September 29, 2023

Subject: PA-2022-099 1855 S. Norfolk St., SUP + SPAR + SDPA
1885 S. Norfolk St., APN 035-383-200

This letter is a follow up to your Planning Application submittal of August 31, 2023. The City's Development Review Board has reviewed your application and found that there are a number of issues that must be addressed. At this time your application is incomplete. Prior to continuing the processing of your application, the information on the attached list must be provided. It is always difficult to identify all issues at this stage of your application, and there may be additional information requested by the Development Review Board, Planning Commission, or City Council during the review process.

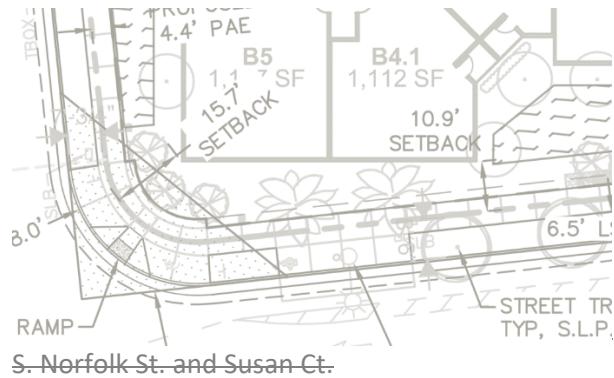
- Please label the distance between the back of the sidewalk or curb and the property line on all street frontages.
- **Cycle 2** The distance between the back of the curb and the property lines is still not clearly labeled. Please see staff's estimated measurements in red below.

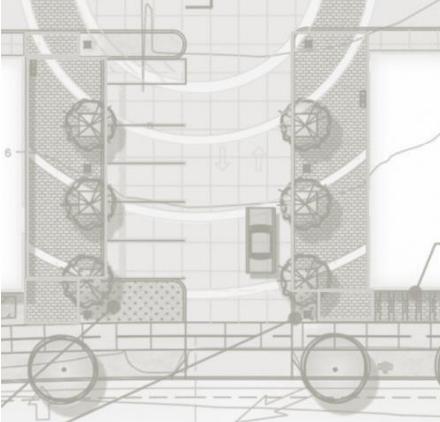
- Please update the arrows provided for the 4.5ft. landscape strip and the 5ft. sidewalk shown along S. Norfolk St. and Susan Ct. Currently it is not clear where each begins and ends since the arrows seem to overlap.

- **Cycle 2** Comment still stands. The arrows provided below still conflict with each other.

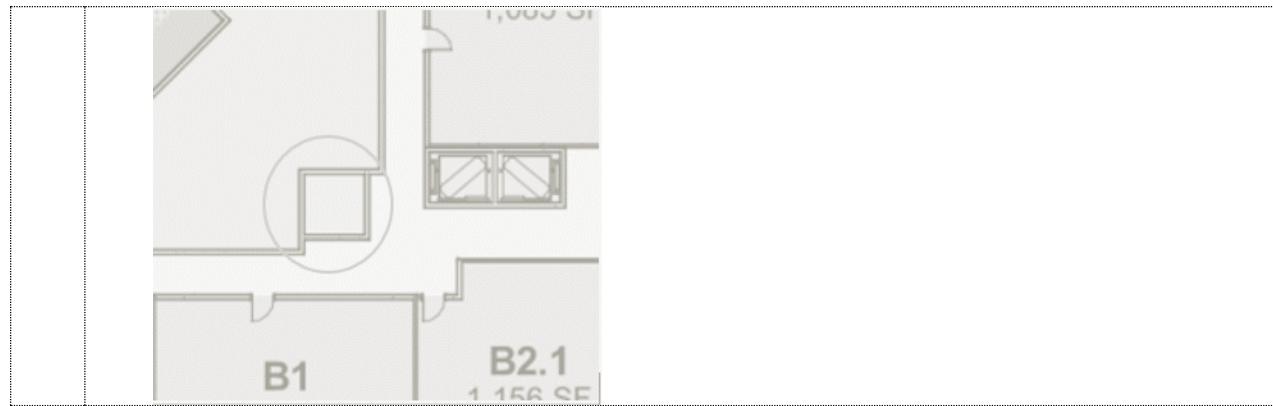
<input type="checkbox"/>	<p>FLOOR PLANS (1/4" scale preferred). Drawn to scale and showing the following:</p> <ul style="list-style-type: none"> ● Proposed floor plans. <ul style="list-style-type: none"> ○ Please provide a legend that corresponds to the colors on the floor plans to identify the proposed use for each space. ● Overall exterior dimensions and individual room dimensions for all levels and stories. <ul style="list-style-type: none"> ○ Please provide overall exterior dimensions of all floors. ○ Please provide enlarged unit plans for each plan type. <ul style="list-style-type: none"> ▪ Cycle 2 – There are only 5 unit plans shown on sheet AP4.00; however, 13 unit types are listed in the project information tables on sheet AP0.00. Please provide unit plans for each type of unit. <ul style="list-style-type: none"> ● Cycle 3 – Floor plans for all units must be included in the plans before they can be deemed complete. ▪ Cycle 2 – Please provide typical room dimensions on unit plans. ● On sheet AP0.03, please provide a breakdown of units by floor for each building. ● Location of all doors and windows, including window sizes. <ul style="list-style-type: none"> ○ Please show and dimension all window and door openings on the floor plans. ▪ Cycle 2 – The unit plans do not show openings for windows. Please dimension and show the windows in each unit plan. The windows shall correspond with the window placement on the proposed elevations. ○ Please see the <i>Design Comments</i> section for information of natural light in the residential corridors. ● Please identify the proposed use(s) that occur on the roof deck. In particular, there is an unlabeled room on the roof deck. Unless exempted by SMMC 27.02.060, rooftop uses such as storage or toilet rooms increase the plateline of the building. <ul style="list-style-type: none"> ○ Cycle 2 – Please provide a section detail of the penthouse. ● Please label all rooms on the floor plan of the North Building. Please see image below.

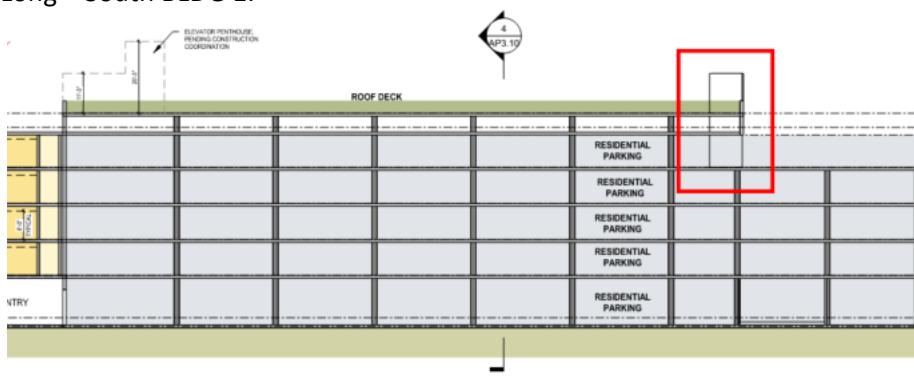
<input type="checkbox"/>	<p>ELEVATIONS (1/4" scale preferred). Drawn to scale and showing the following:</p> <ul style="list-style-type: none"> • The proposed structure(s) <ul style="list-style-type: none"> ○ The roof over the garage access shown on Elevation – North Building – Norfolk St. 1, Building is different than the roof shown on Elevation – North Building – Garage Access 2. Please update the elevations as necessary. ○ Please clarify in the elevations the area of the North Building identified as "unoccupied roof". • Building plate height measured from existing grade to top of building plate line. This height is measured from existing grade at any point along the perimeter of a building, to the highest plate line of the structure directly above that point, regardless of whether that point is on the same plane as the building where it touches the ground (see Zoning Code § 27.04.080). <ul style="list-style-type: none"> ○ For all elevations, please place this measurement on both sides of the building. ○ Cycle 2 – Please remove all references to average grade plane height. Average grade is not used to determine building height for Zoning compliance. ○ Cycle 2 – Please provide the top plate line measurement for each top plate on each elevation. Only include height measurements for portions of the building on the subject elevation. If the highest plate line is not on the side of the building being measured, it should not be shown. This means that each elevation may have different top plate heights. <ul style="list-style-type: none"> ▪ Cycle 3 – The building sections shown on AP3.10 show the top platelines as the ceiling heights on highest floor. This is incorrect. "Plateline" means the line established by the horizontal girder which supports the trusses or rafters of a roof. • Building total height measured from existing grade to top of building roof peak. <ul style="list-style-type: none"> ○ For all elevations, please place this measurement on both sides on the building. ○ Cycle 2 – Please remove all references to grade plane height. Average grade is not used to determine building height for Zoning compliance. ○ Cycle 2 – Each elevation shall have its own peak of roof measurement. Only include height measurements for portions of the building on the subject elevation. If the highest peak is not on the side of the building being measured, it should not be shown. This means that each elevation may have different roof peak heights. • Types and colors of exterior materials for siding, roof, trim, railings, eaves, other architectural detailing, and windows for both existing and new. Show window grid patterns, window operation types, and any obscured glazing. Note roof pitch(es). <ul style="list-style-type: none"> ○ Please provide a materials board for building materials.

- Please confirm if all balconies, excluding the top floor balconies, will be covered.
- Please see the *Design Review* section below of additional comments on the elevations.
 - **Cycle 2** – Comment still stands.
- **Cycle 2** – Please verify whether the elevator penthouse/lobby will be visible from the Fashion Island Blvd. crossing or from the pedestrian level. The penthouse appears to exceed the height of the roof, so should be shown and dimensioned on the applicable elevations. Please see the *Other Concerns* section below.
 - **Cycle 3** – Please address the Cycle 2 comment above. Is the penthouse visible from the Fashion Island Bridge? Additional comments may follow response.
- **Cycle 2** – Please clearly label where each material and color are used on the elevations.
